Bid Addendum

Bid Title: P.O.Hoffer Water Treatment Facility Glenville Lake Water Treatment Facility Post-Filter GAC Adsorption Facilities Contract No.67

Addendum Number: 2

ADDENDUM NO. 2 – TECHNICAL SPECIFICATIONS AND DRAWINGS

ENLARGED TOP PLAN

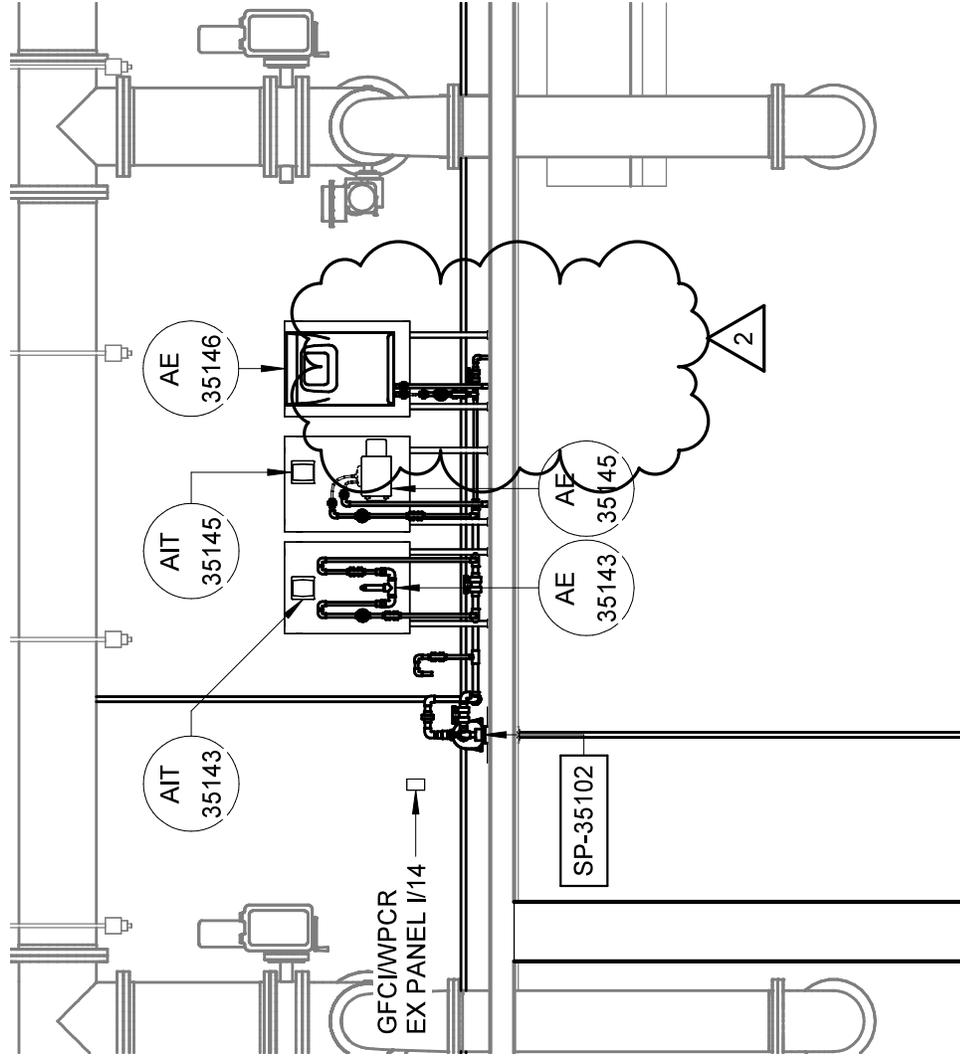
- E101 Revised Enlarged Floor Plan to remove AIT-35146, as shown in **Attachment #1.**

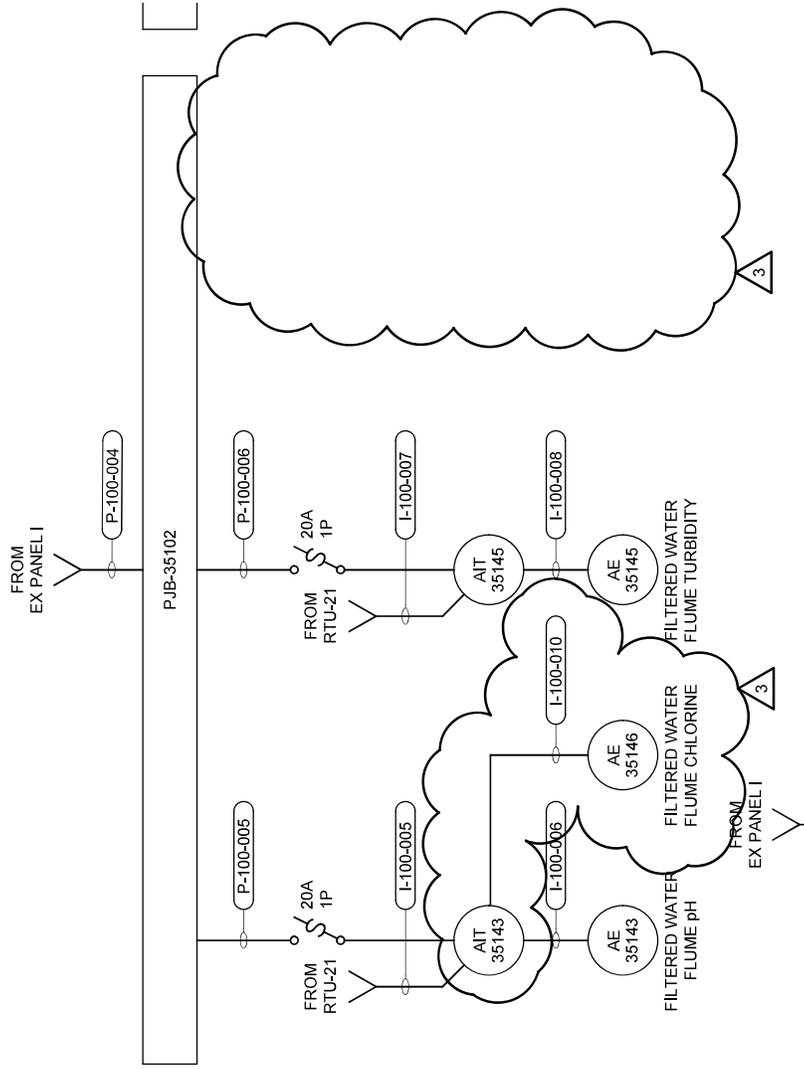
- E103 Revised Instrument Riser Diagram to remove AIT-35146 and reconnecting AE-35146 to AIT-35143, as shown in **Attachment #4.**

ATTACHMENT NO. 5	BY DCH	GLENVILLE LAKE AND P.O. HOFFER WATER TREATMENT FACILITIES	CONTRACT NUMBER 67	SHEET 3 OF 3
ADDENDA NO. 002	DATE 01/2026	CITY OF FAYETTEVILLE, NORTH CAROLINA	HAZEN JOB NUMBER 30402-067	REFER TO CONTRACT DRAWING NUMBER E103

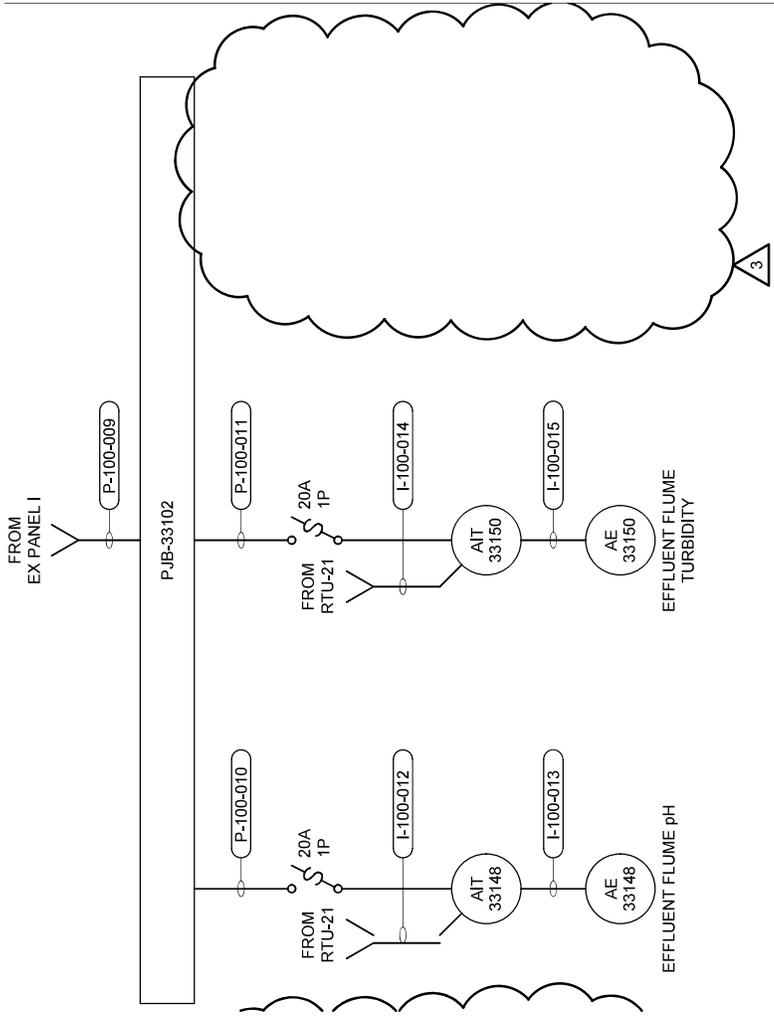
- E103 Revised Instrument Riser Diagram to remove AIT-33151 and AE-33151, as shown in **Attachment #5.**

ATTACHMENT NO. 7	BY DCH	GLENVILLE LAKE AND P.O. HOFFER WATER TREATMENT FACILITIES
ADDENDA NO. 002	DATE 01/2026	CITY OF FAYETTEVILLE, NORTH CAROLINA
HAZEN JOB NUMBER 30402-067	REFER TO CONTRACT DRAWING NUMBER E210	CONTRACT NUMBER 67
SHEET 1 OF 1

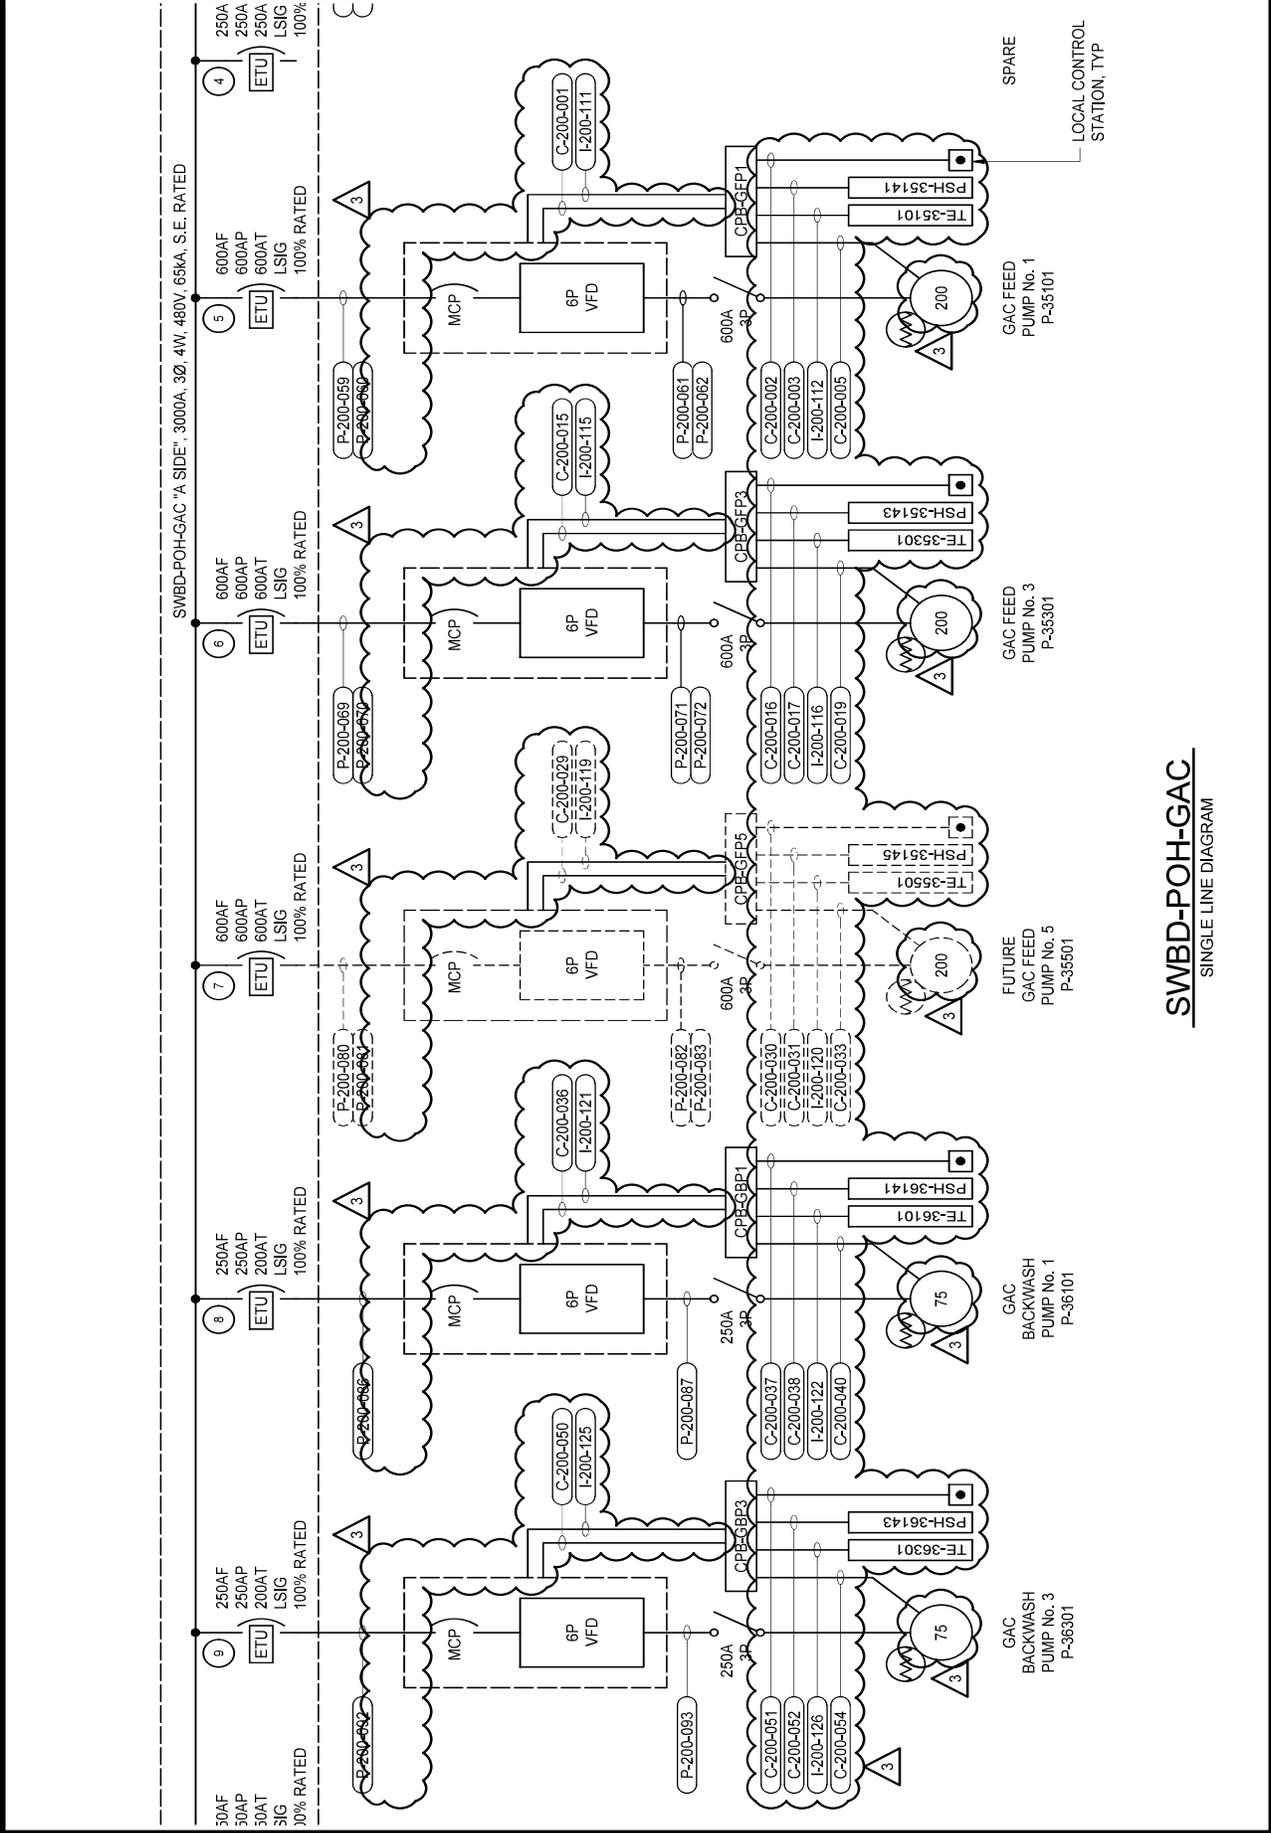
- E210 Revised SWBD-POH-GAC single line diagram - Updated GAC backwash and feed pump horsepower. Revised conduits from GAC backwash and feed pump VFDs to the control pull box. Added GAC backwash and feed pump RTDs from VFDs to motors, as shown in **Attachment #7.**

ATTACHMENT NO. 8	BY DCH	GLENVILLE LAKE AND P.O. HOFFER WATER TREATMENT FACILITY	SHEET 1 OF 1
ADDENDA NO. 002	DATE 01/2026	CITY OF FAYETTEVILLE, NORTH CAROLINA	CONTRACT NUMBER 30402-067
		PUBLIC WORKS COMMISSION	HAZEN JOB NUMBER 30402-067
			REFER TO CONTRACT DRAWING NUMBER E211

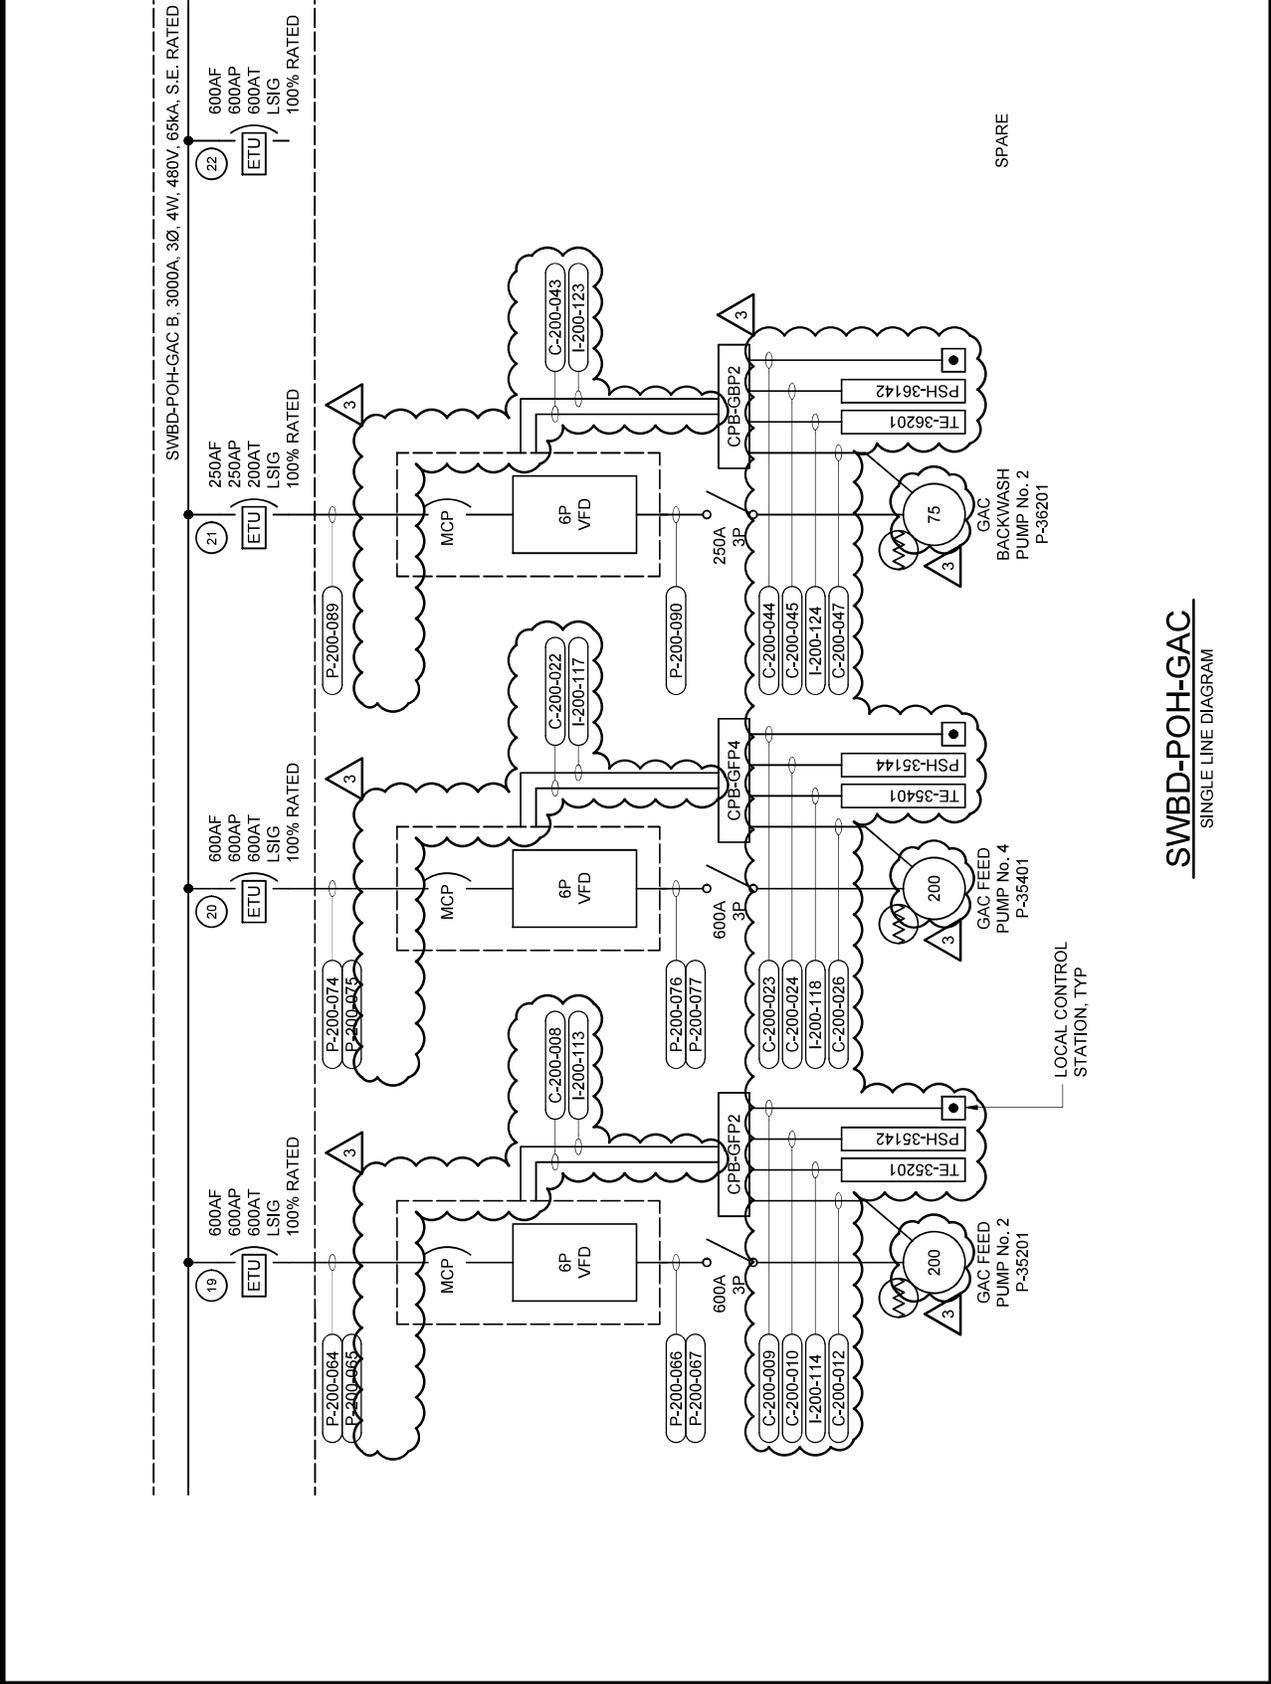
- E211 Revised SWBD-POH-GAC single line diagram – Updated GAC backwash and feed pump horsepower. Revised conduits from GAC backwash and feed pump

VFDs to the control pull box. Added GAC backwash and feed pump RTDs from VFDs to motors, as shown in **Attachment #8**.

ATTACHMENT NO. 11	BY DCH	GLENVILLE LAKE AND P.O. HOFFER WATER TREATMENT FACILITIES	CONTRACT NUMBER 67	SHEET 1 OF 2
ADDENDA NO. 002	DATE 01/2026	CITY OF FAYETTEVILLE, NORTH CAROLINA	HAZEN JOB NUMBER 30402-067	REFER TO CONTRACT DRAWING NUMBER E452

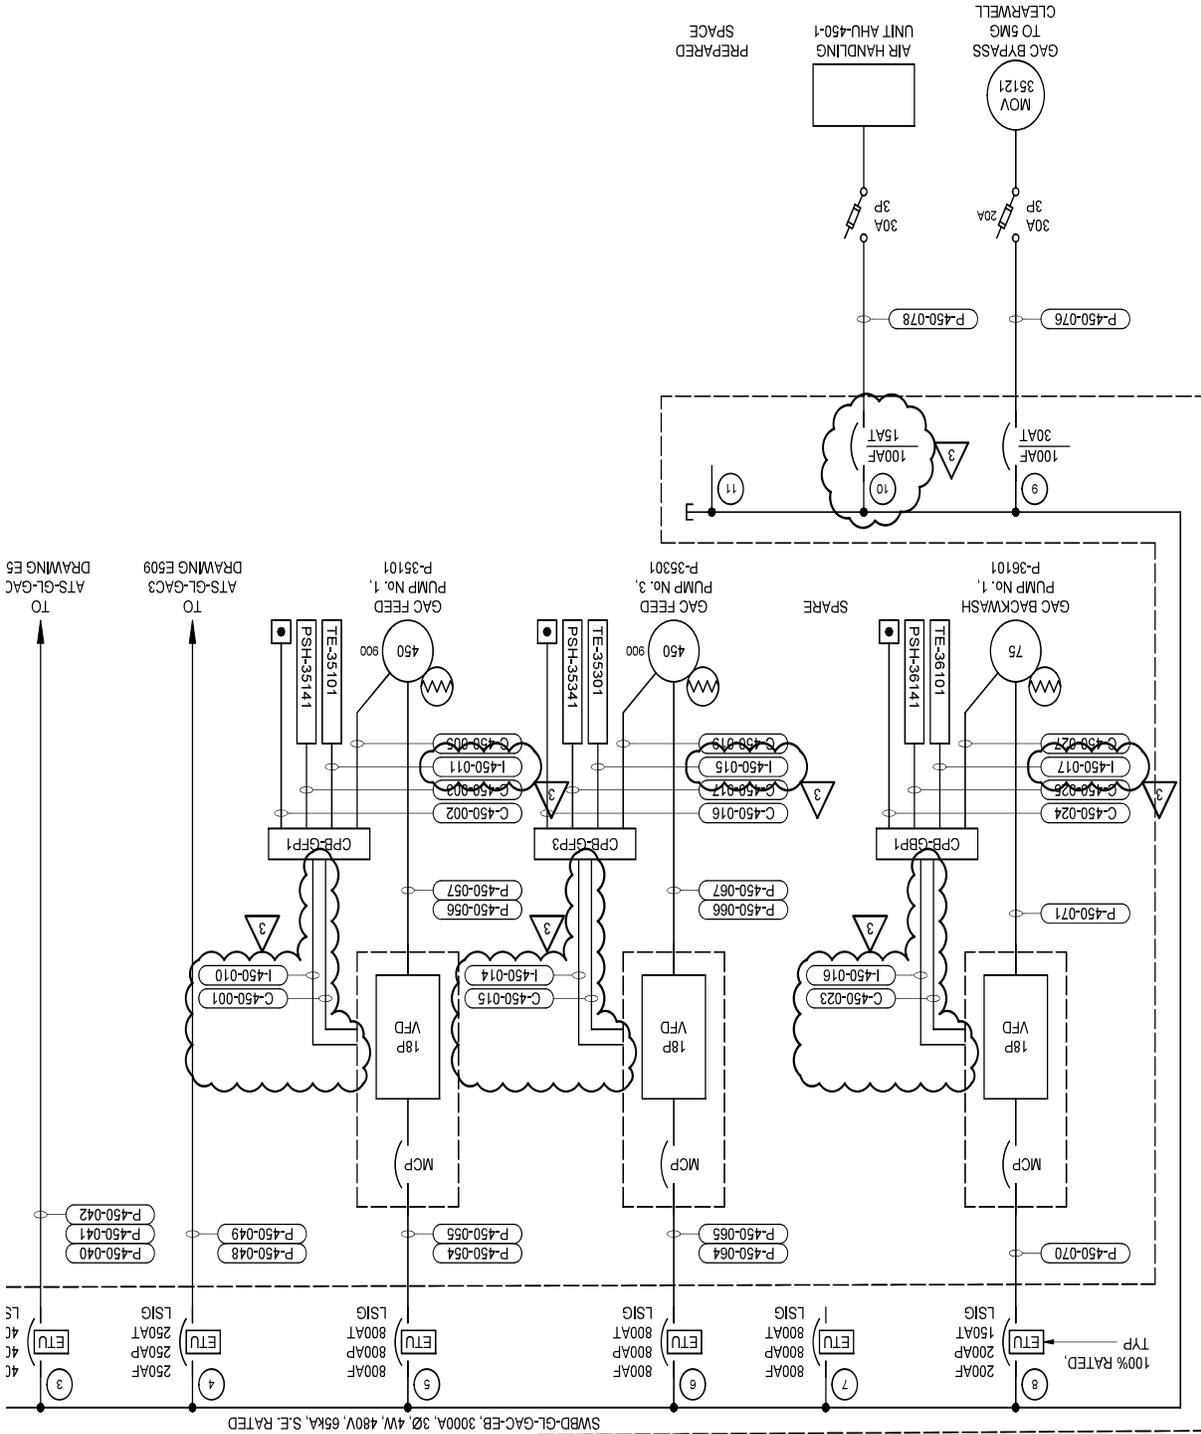
- E452 Revised SWBD-GL-GAC single line diagram - Updated GAC backwash and feed pump horsepower. Revised conduits from GAC backwash and feed pump VFDs to the control pull box. Added GAC backwash and feed pump RTDs from VFDs to motors, as shown in **Attachment #11**.

ATTACHMENT NO. 12	BY DCH	GLENVILLE LAKE AND P.O. HOFFER WATER TREATMENT FACILITIES	CONTRACT NUMBER 67	SHEET 2 OF 2
ADDENDA NO. 002	DATE 01/2026	CITY OF FAYETTEVILLE, NORTH CAROLINA	HAZEN JOB NUMBER 30402-067	REFER TO CONTRACT DRAWING NUMBER E452

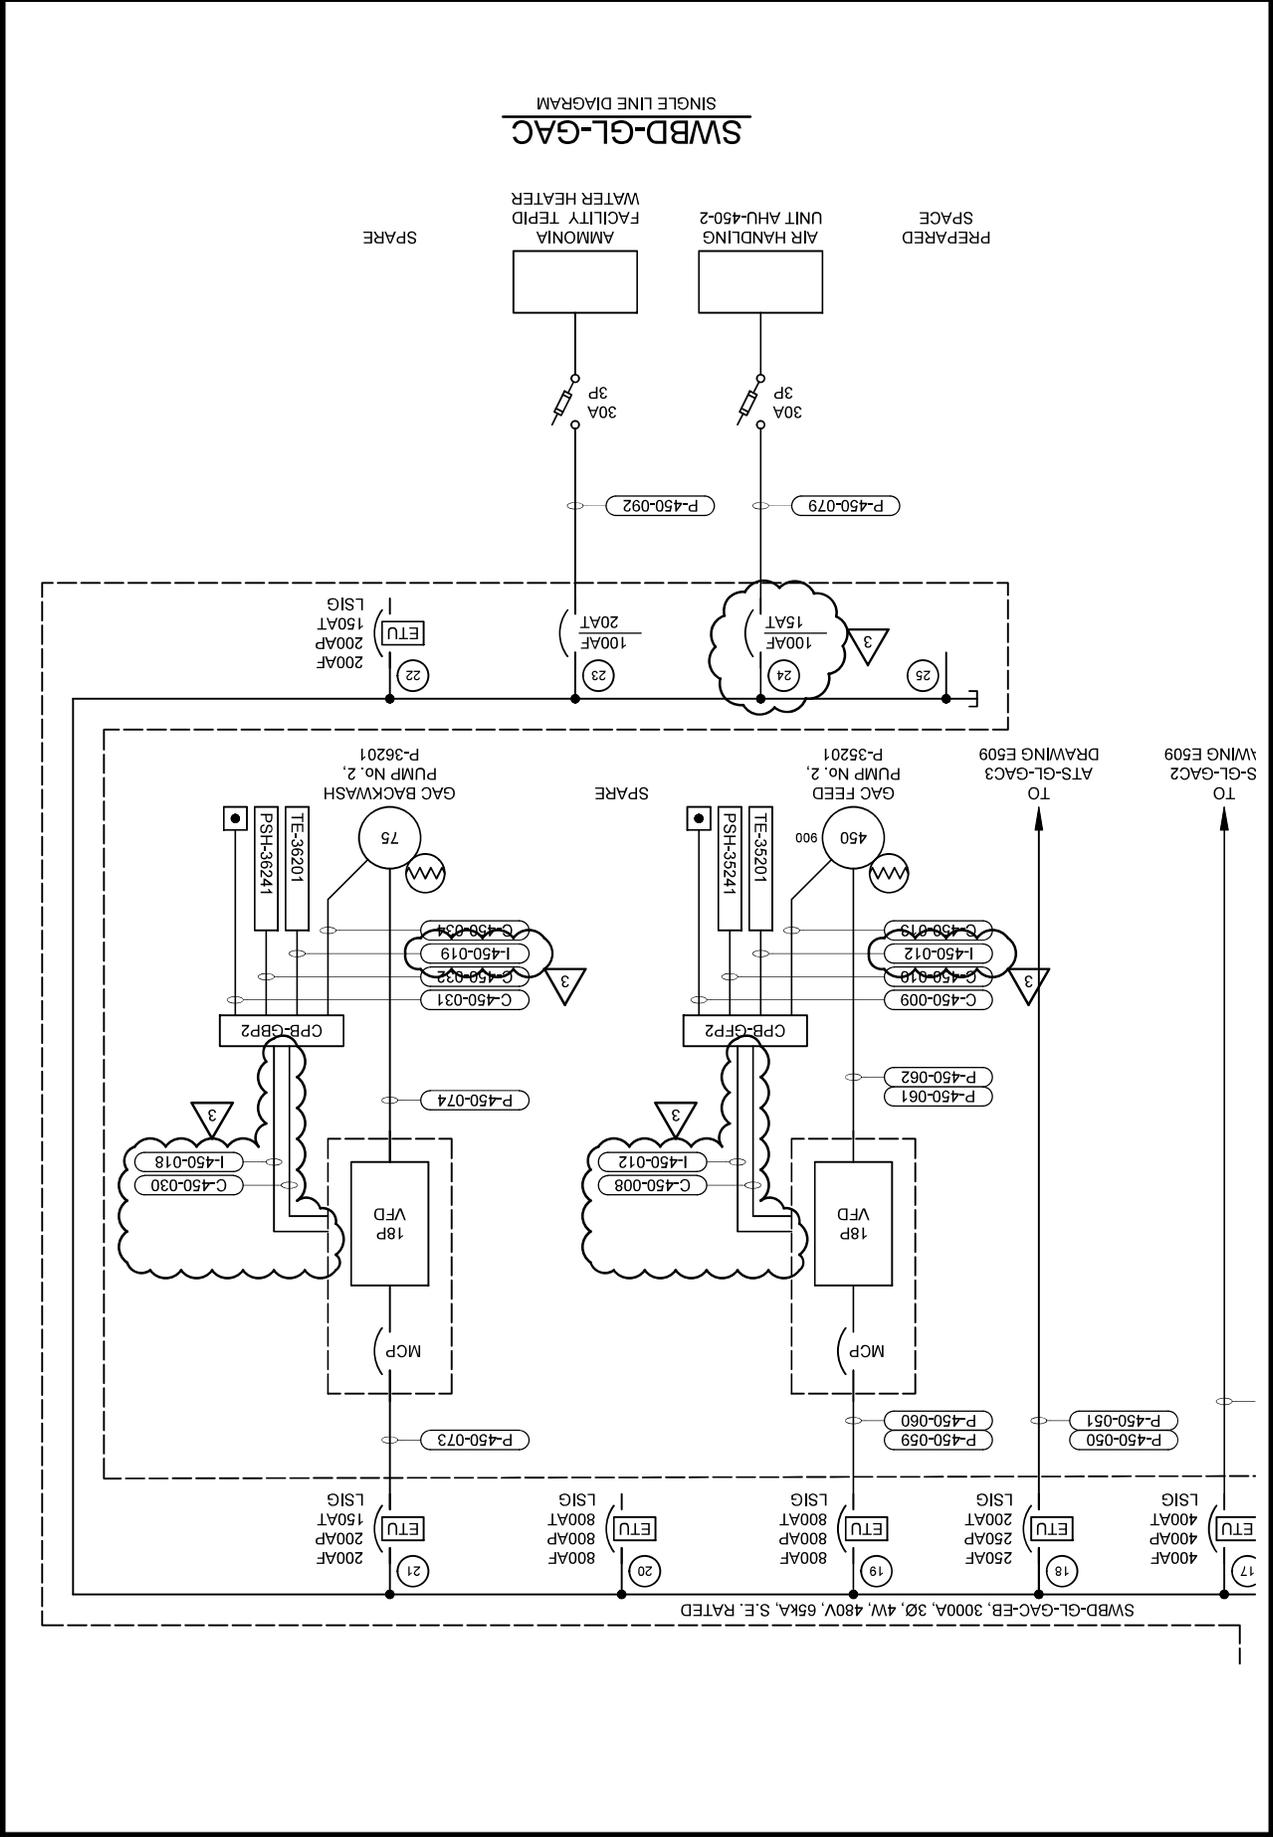
- E452 Revised SWBD-GL-GAC single line diagram - Updated GAC backwash and feed pump horsepower. Revised conduits from GAC backwash and feed pump VFDs to the control pull box. Added GAC backwash and feed pump RTDs from VFD to motors, as shown in **Attachment #12**.
